HISTORIC DISTRICT COMMISSION
STAFF REPORT

5:30 pm • September 24, 2018 • City Hall

C1 ADDITION AND RENOVATIONS - 1720 BRUCE STREET

C2 NEW SINGLE-FAMILY RESIDENCE - 1927 COLLEGE AVENUE

FRONT ELEVATION

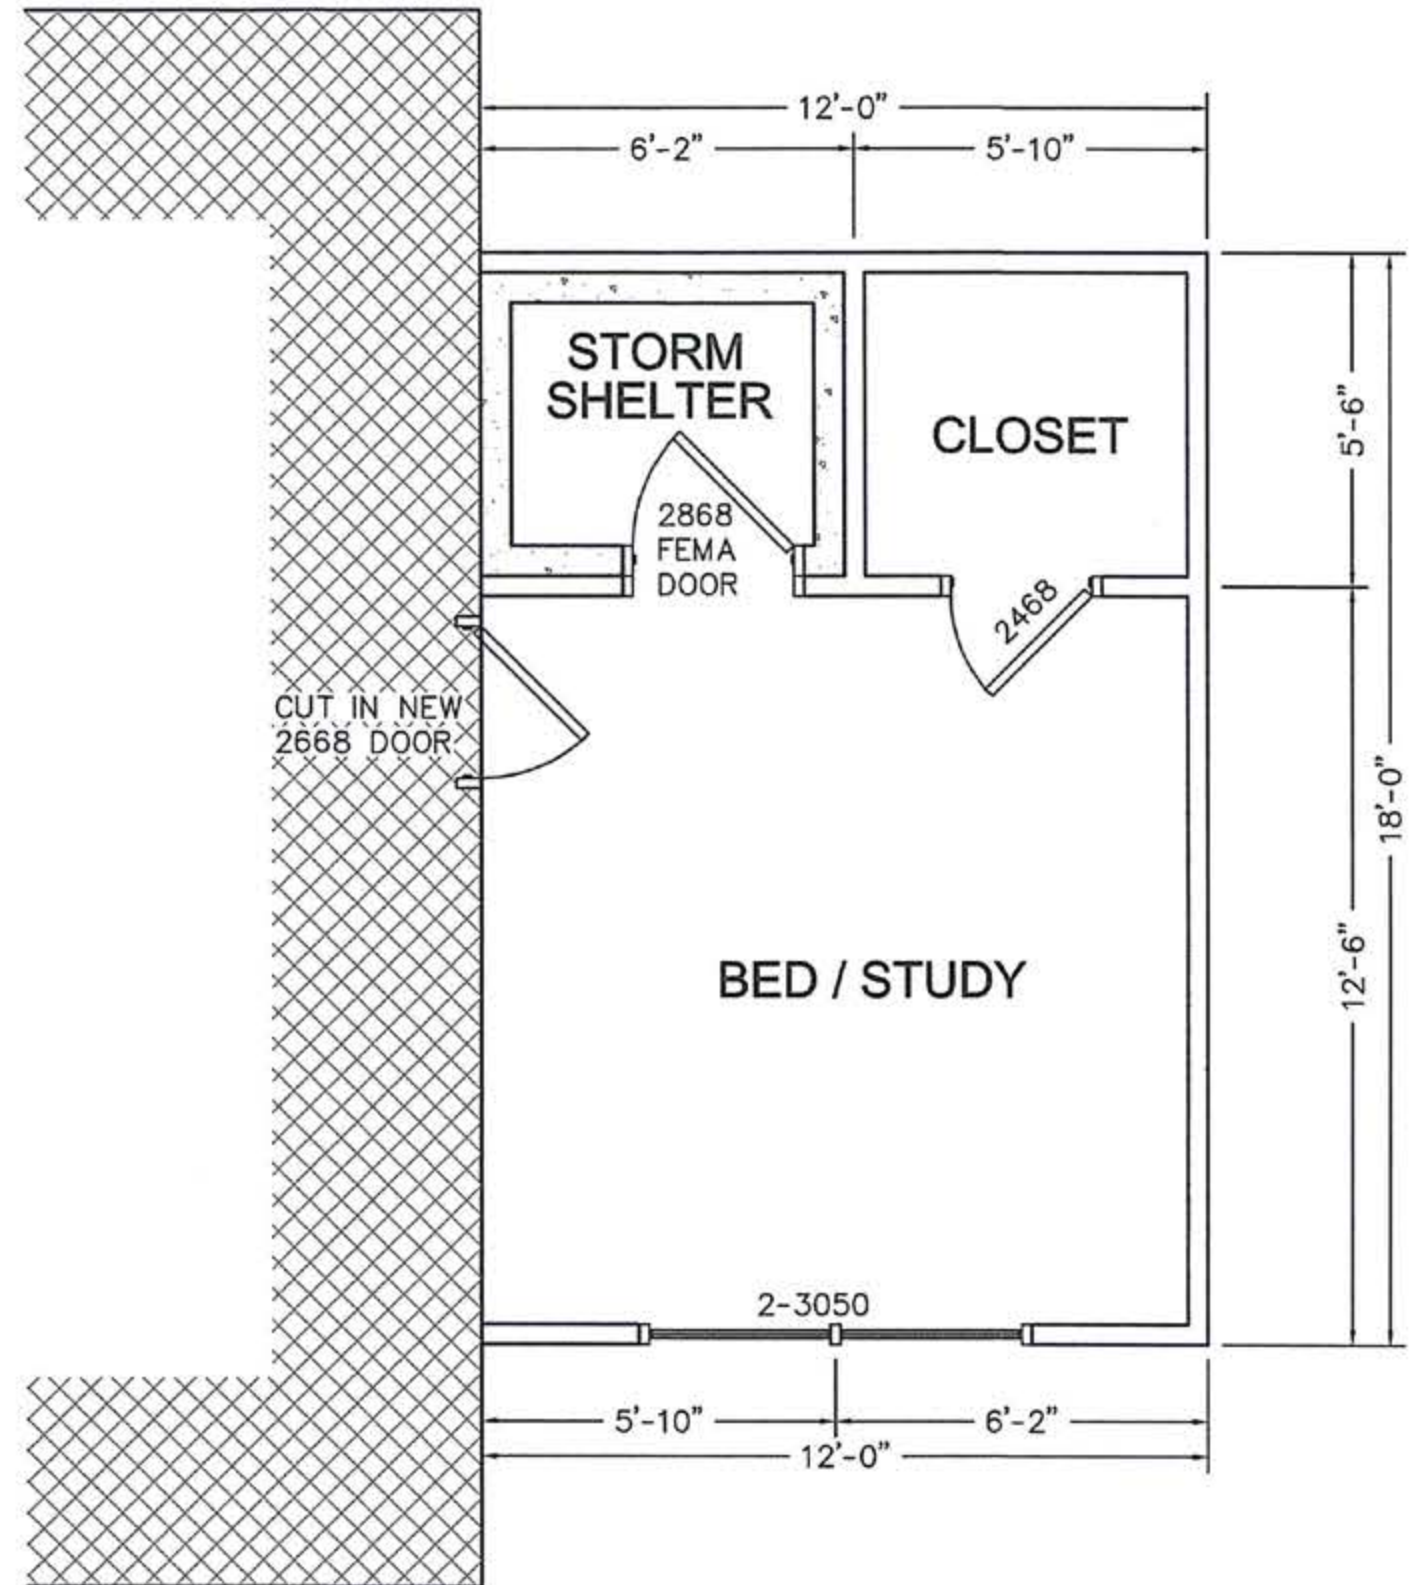
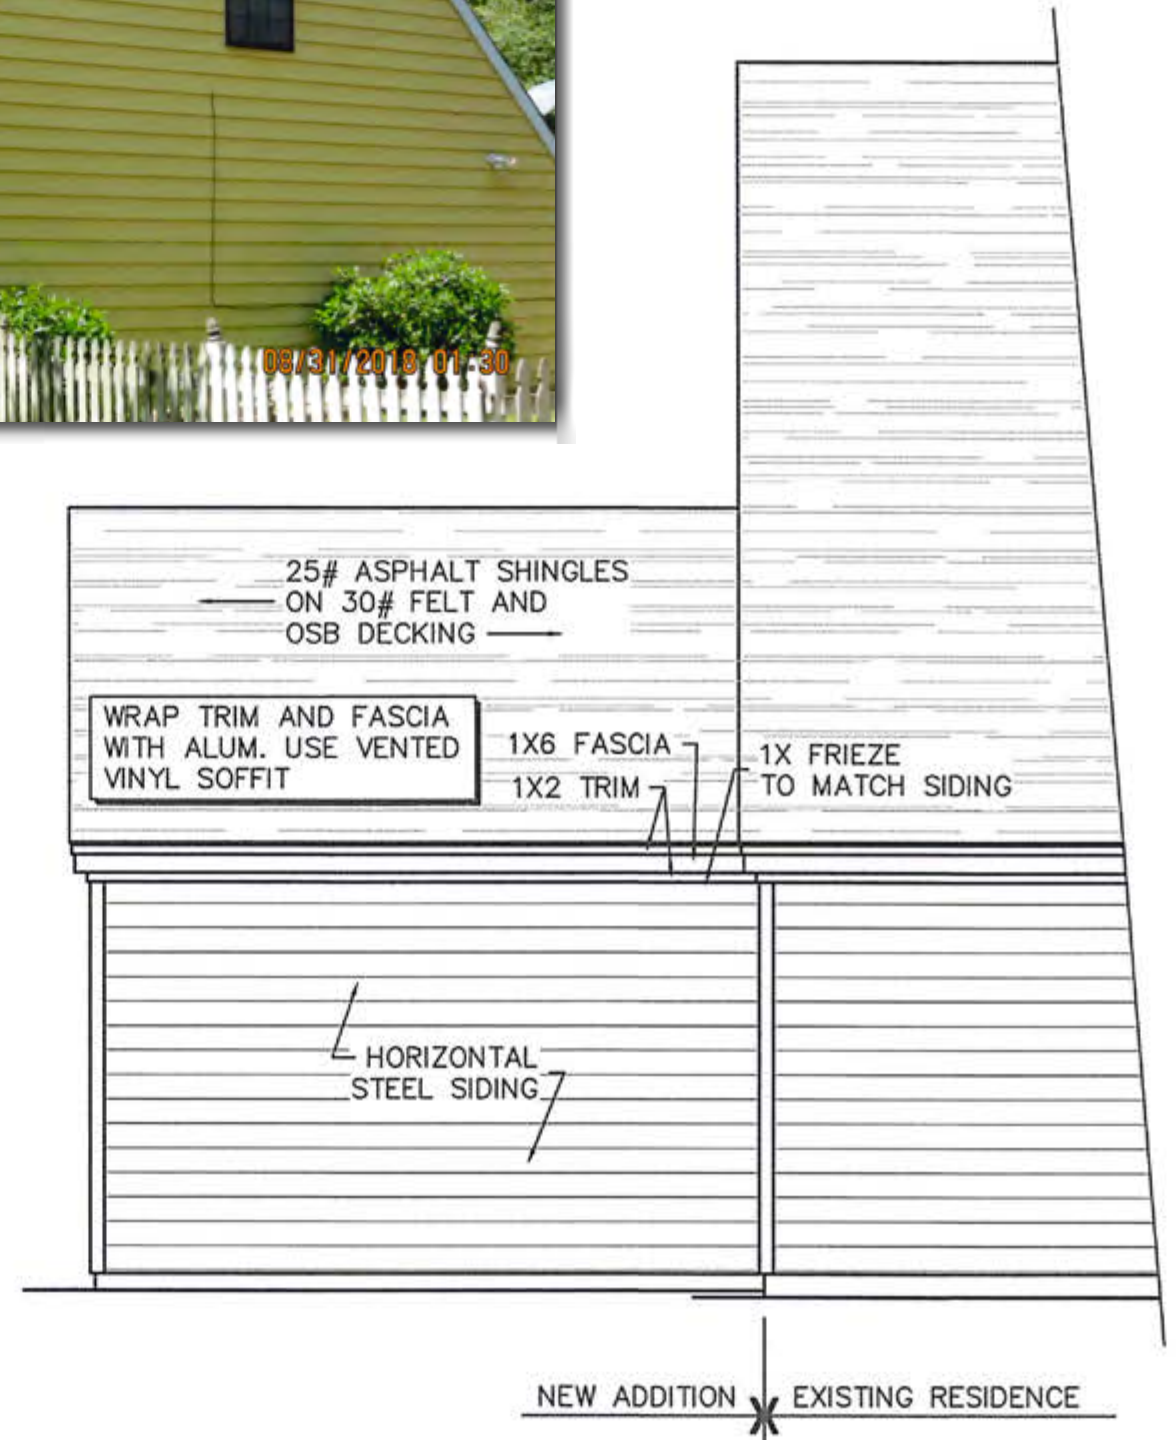
Facade, wall area, rhythm. Facades shall be compatible with surrounding historic structures in proportion of wall to opening area. The proportion of wall to opening area will continue with the addition.

Style. The style should compliment the existing and area structures. The residence is in a two story Cape Cod style. The addition will continue this style.

Doors and windows. New windows are proposed on the front facade of the addition facing Bruce Street. The windows will match existing windows with 6 over 6 dividers. No new doors are proposed.

Shutters. If used, shutters should be in proportion to their window opening. If they were closed, they should cover the window opening. There are currently shutters on the Bruce Street facade. These shutters are not appropriately sized however, they are existing. The proposed shutters for the addition would match the existing shutters.

Roof. An asphalt roof is proposed for the new addition area.

1. The addition shall be constructed as shown on the submitted plans.
2. New shutters matching the existing shall be allowed.
3. Matching windows with false dividers shall be allowed.
4. Asphalt roof matching existing shall be used.
5. Matching horizontal steel siding shall be allowed.

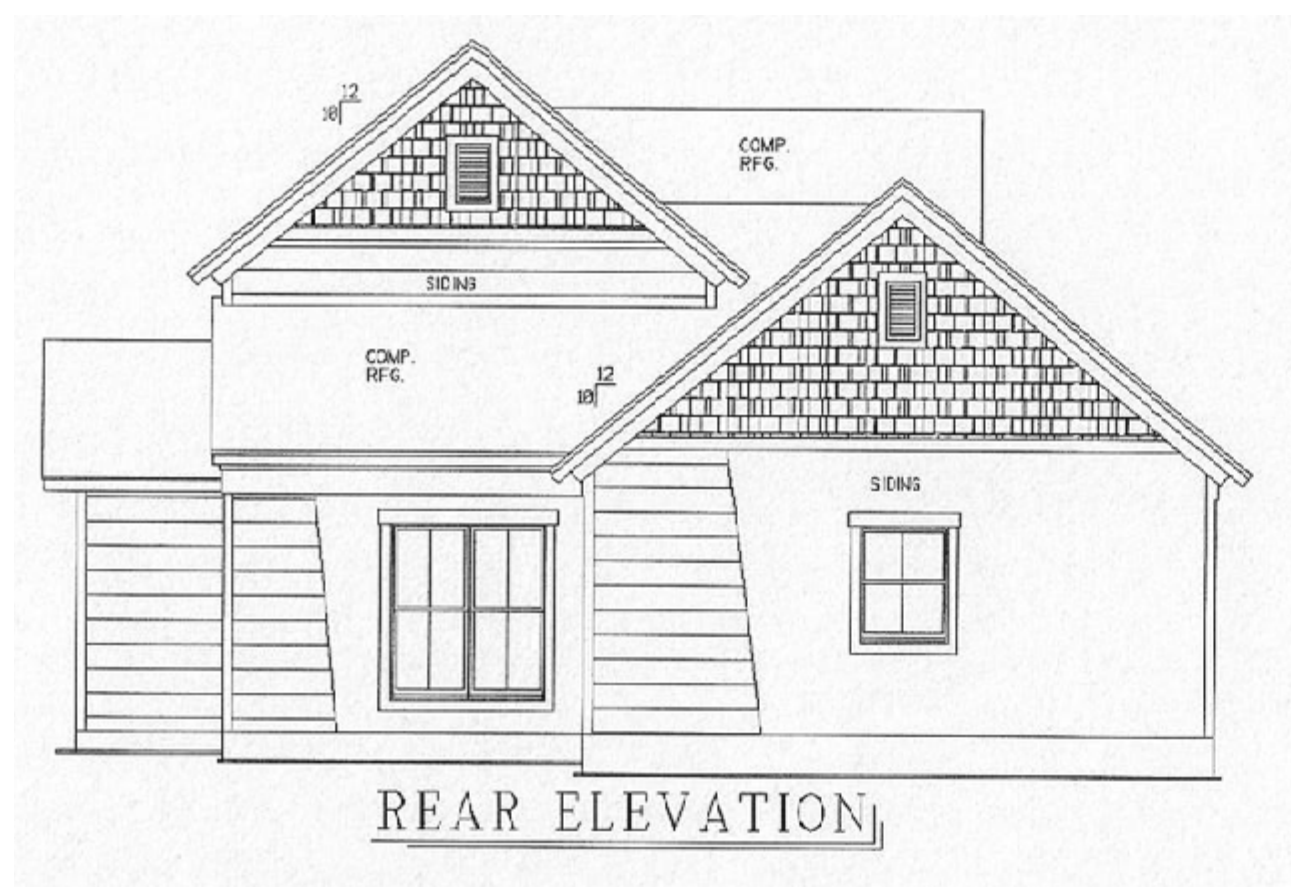
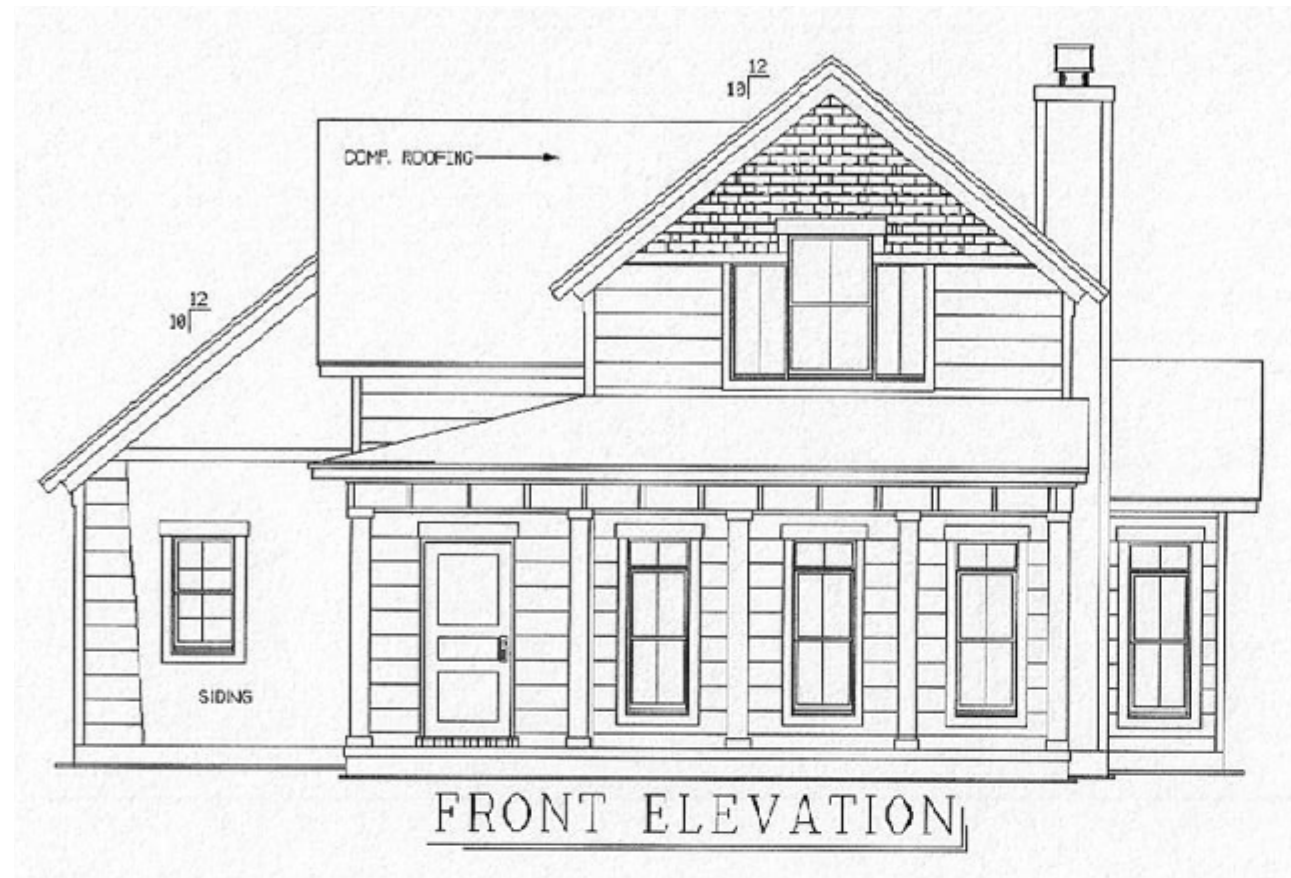
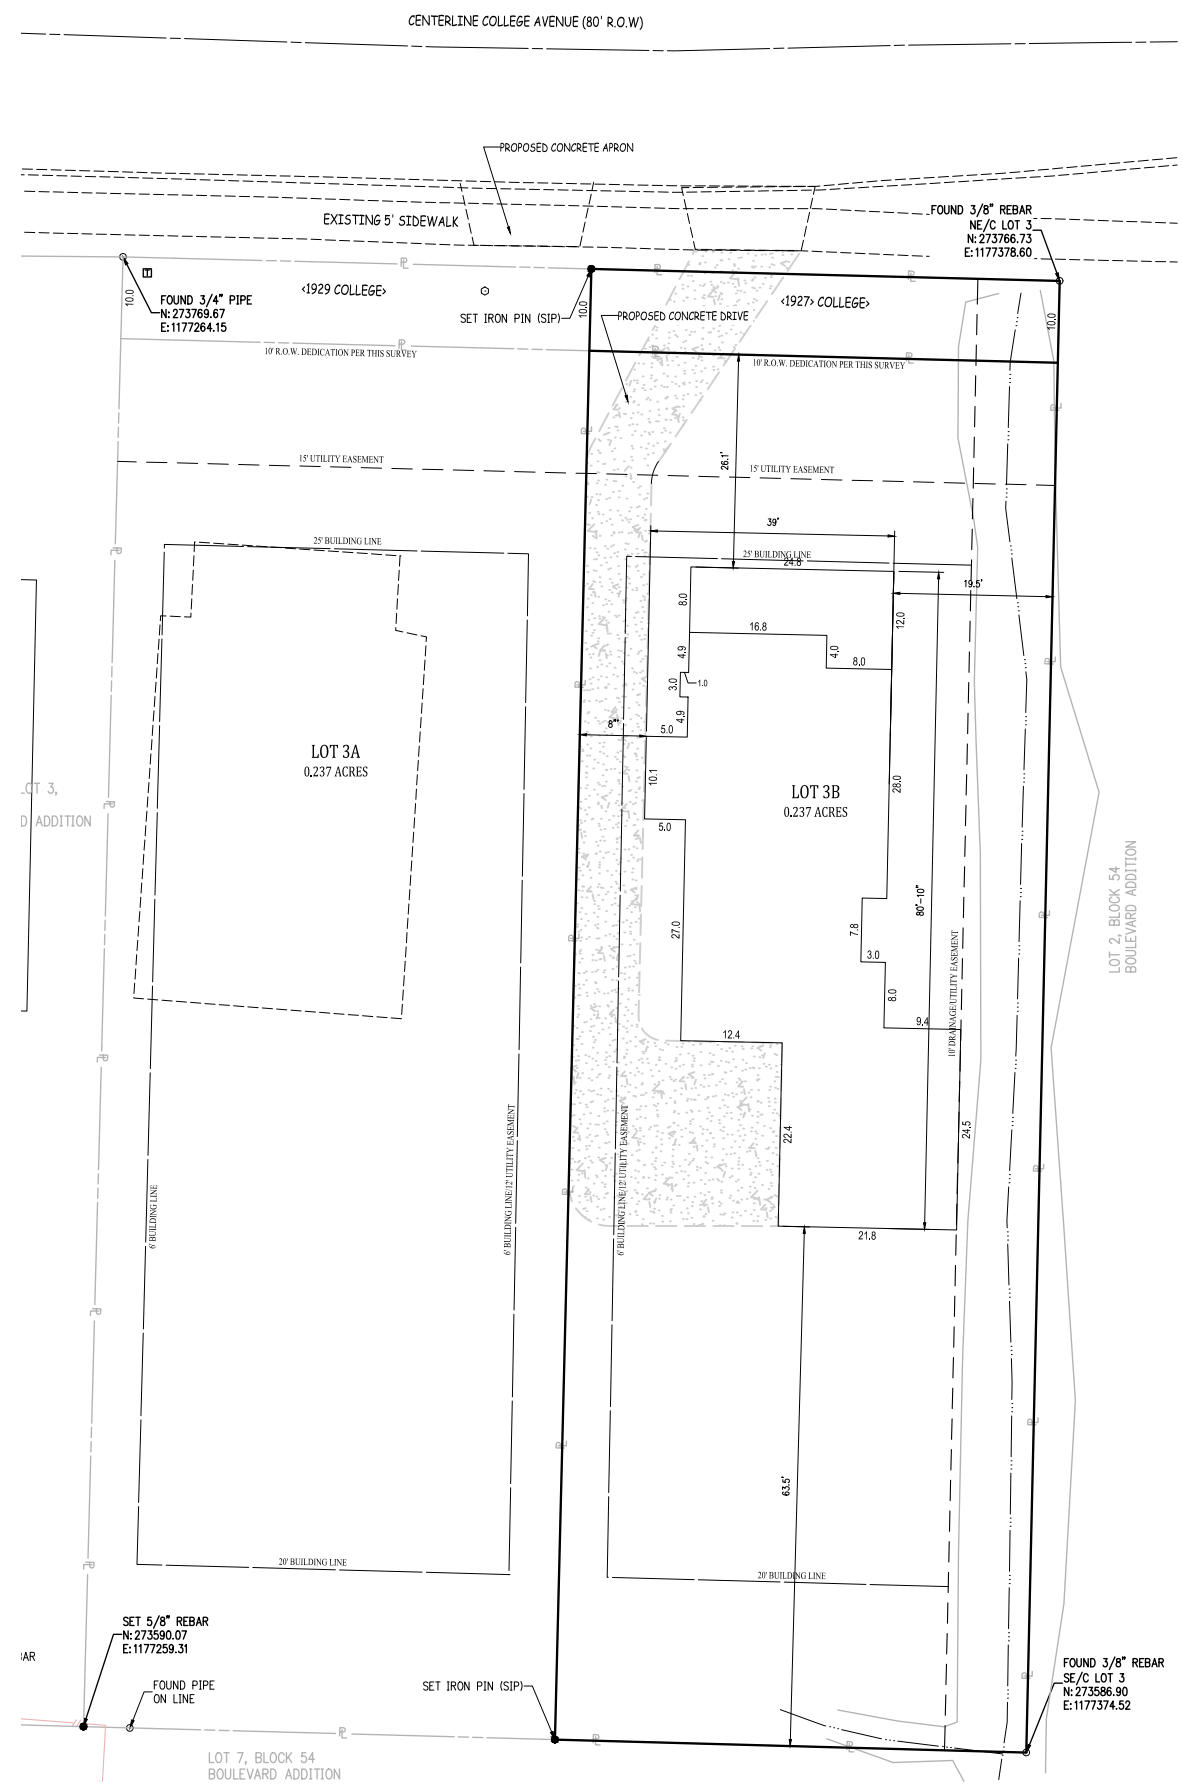
Height. The average height of area structure's eaves and cornices. Also, the first floor elevation / height relationship. The overall height and eave lines are appropriate. The floor to ceiling height is shown as 9 feet minimum. The overall height of the residence will blend with area residences.

Facade, wall area, rhythm. Facades shall be compatible with surrounding historic structures in proportion of wall to opening area. The residence appears to have an appropriate number of windows and doors - void to solids ratio.

Style. The style should compliment the existing and area structures. The residence is a modern interpretation of vernacular farmhouse style. This should blend with area historic structures.

Entries, Porches, and Porticos. Appropriate entry points are provided. Porches are to be a minimum of 6 feet in depth. The front porch shown is shown at 8' minimum in depth. Porch columns are shown with substantial width.

Doors and windows. Windows are shown with muntin dividers creating mostly two over two windows. Simple one over one windows would be more appropriate than windows with false dividers. The front facade windows appear to have transom lites.

Architectural Details, Siding, and Bricks. Eaves, brackets, dentils, cornices, molding, columns, trim, etc. The residence has detailing provided through wide door and window trim, front porch rafter brackets, and varying siding. These features add traditional detailing. The applicant has not provided the type of siding material. Fiber cement siding is preferred.

1. The residence shall be constructed as shown in submitted plans.
2. The residence's front setback shall be approximately 46 feet from the curb or 26.1 feet from the newly platted north property line.
3. A canopy tree with a minimum 2" caliper shall be planted to remediate removal of the two large trees.
4. Floor to ceiling height shall be 9 feet minimum.
5. Siding material shall be fiber cement siding such as Hardie board or similar.
6. One over one windows may be used in lieu of false window dividers.
7. Wide trim around windows and doors shall be used as shown.
8. Concrete driveway shall be nominally 8 feet wide accessing the rear garage.
9. HVAC and utility equipment shall be appropriately located at the rear or side of the structure and/or appropriately screened.
10. Any damage to the sidewalk during construction shall be repaired.
